Form 3160-5
(June 2019)UNITED STATES
DEPARTMENT OF THE INTERIOR
BUREAU OF LAND MANAGEMENTFORM APPROVED
OMB No. 1004-0137
Expires: October 31, 2021**SUNDRY NOTICES AND REPORTS ON WELLS**
Do not use this form for proposals to drill or to re-enter an abandoned well. Use Form 3160-3 (APD) for such proposals.

Operator: Hudson Oil Company of Texas
 Well Name: Shugart B #4
 Field: Shugart Queen
 County/State: Eddy County, New Mexico
 API Number: 30-015-05520
 Lease Number: LC-062052
 Location: Sec 11 - T18S - R31E
 1980' FSL & 660' FWL

Sundry ID 2663670

Proposed

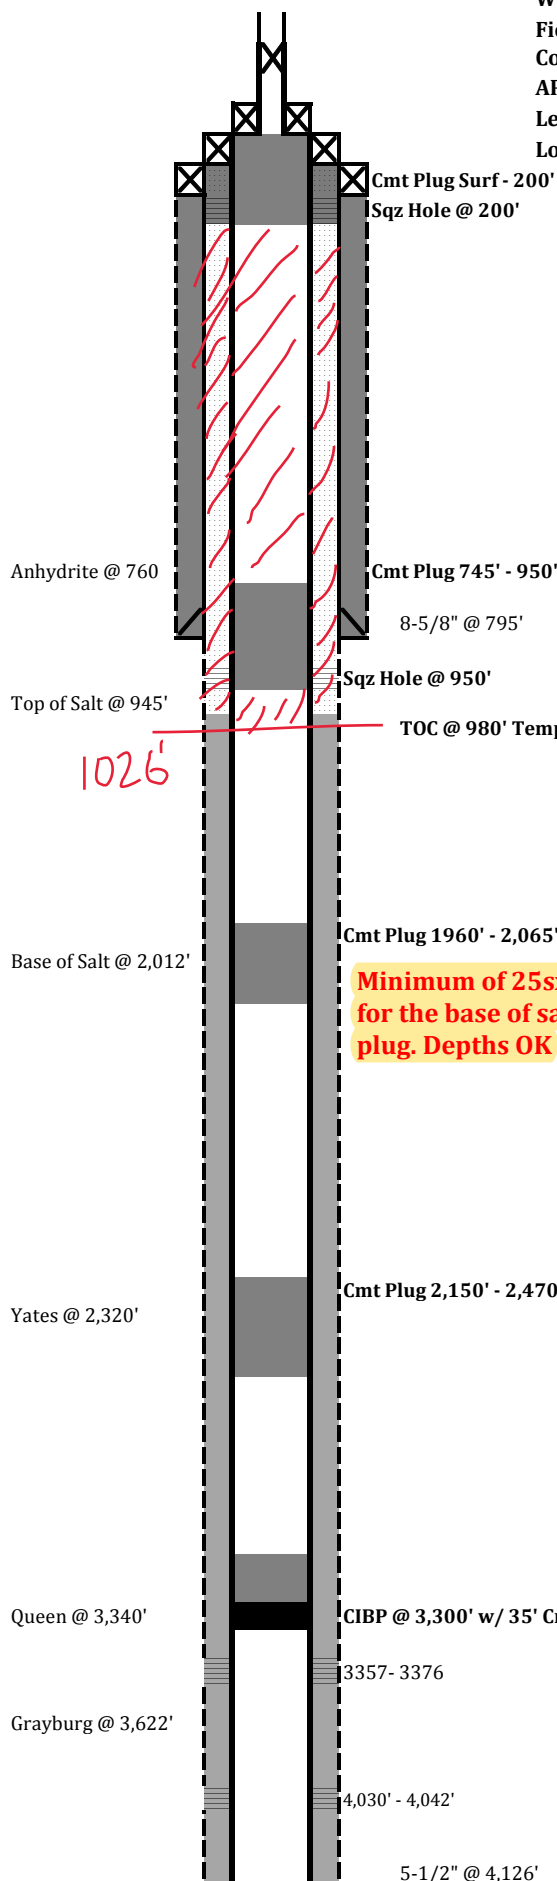
Only one cemented annulus covers the fresh water zone. Perf and squeeze cement to surface with base at 980 in the 5.5"-8.625" annulus and 1026' inside the 5.5" casing. Minimum 130sx in annulus and 110sx in casing. Or cut and remove casing right above TOC. Set plug base at 1026' and bring it to surface with 280sx of cement. Covers all above plugs including surface plug

Minimum of 25sx for the base of salt plug. Depths OK

Minimum of 25sx for the Yates plug. Depths OK

Minimum 25sx cement on top of CIBP. Pressure test to 500psi for 30mins.

Perf and squeeze cement to surface with base at 980 in the 5.5"-8.625" annulas and 1026' inside the 5.5" casing. Minimum 130sx in annulas and 110sx in casing. Or cut and remove casing right above TOC. Set plug base at 1026' and bring it to surface with 28
Top of Salt @ 976	916.24	1026.00	109.76	Tag/Verify	240 or 280	
Base of Salt @ 2046	1975.54	2096.00	120.46	Tag/Verify	25.00	Minumum of 25sx of Class C cement
				If solid base no need to Tag (CIBP present and/or Mechanical Integrity Test), If Perf & Sqz then Tag, Leak Test all CIBP if no Open Perforations		Perf and squeeze cement to surface with base at 980 in the 5.5"-8.625" annulas and 1026' inside the 5.5" casing. Minimum 130sx in annulas and 110sx in casing. Or cut and remove casing right above TOC. Set plug base at 1026' and bring it to surface with 280sx of cement. Covers all above plugs including surface plug
Fresh Water @ 820	761.80	870.00	108.20		240 or 280

Perf and squeeze cement to surface with base at 980 in the 5.5"-8.625" annulas and 1026' inside the 5.5" casing. Minimum 130sx in annulas and 110sx in casing. Or cut and remove casing right above TOC. Set plug base at 1026' and bring it to surface with 280sx of cement. Covers all above plugs including surface plug
Shoe Plug	737.05	845.00	107.95	Tag/Verify	240 or 280

CIBP Plug	3265.00	3300.00	35.00	If solid base no need to Tag (CIBP present and/or Mechanical Integrity Test), If Perf & Sqz then Tag, Leak Test all CIBP if no Open Perforations	25.00	Minimum of 25sx Class C cement. Test to 500psi for 30mins
-----------	---------	---------	-------	--	-------	---
